LCAN1/0-56-X
Copper Lug - One-Hole, Narrow Tongue, Standard Barrel

SCALE N/A DRAWING NO / CAD FILE LCAN1_0-56-CUST

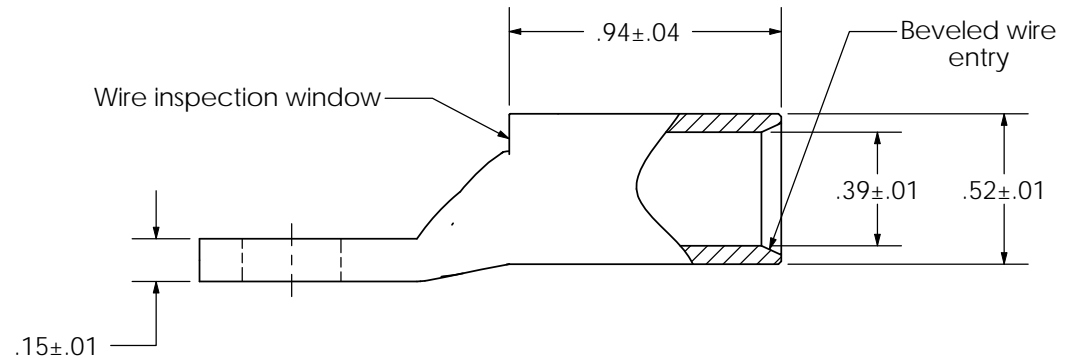
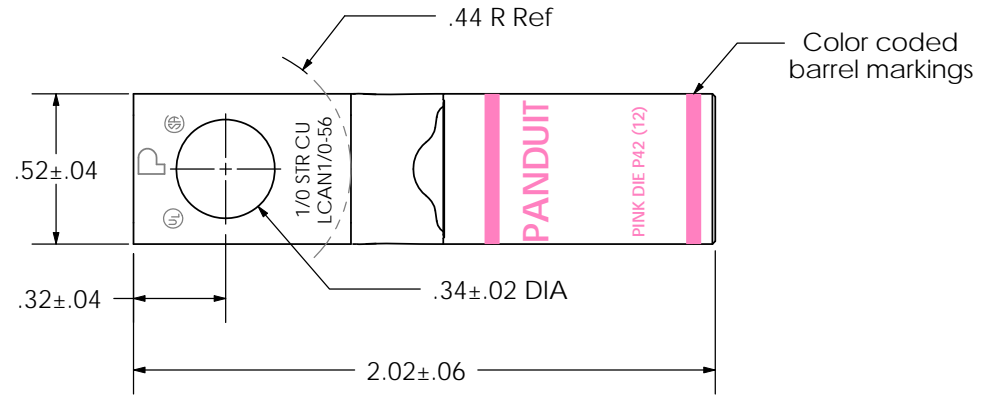
REV	DATE	BY	CHK	DESCRIPTION	ECN	SCALE	DRAWING NO / CAD FILE
01	1/11	JHNU	JHNU	REVISED OVERALL LENGTH: WAS 2.00 REVISED TONGUE THICKNESS: WAS .13		N/A	LCAN1/0-56-X Copper Lug - One-Hole, Narrow Tongue, Standard Barrel
							LCAN1_0-56-CUST
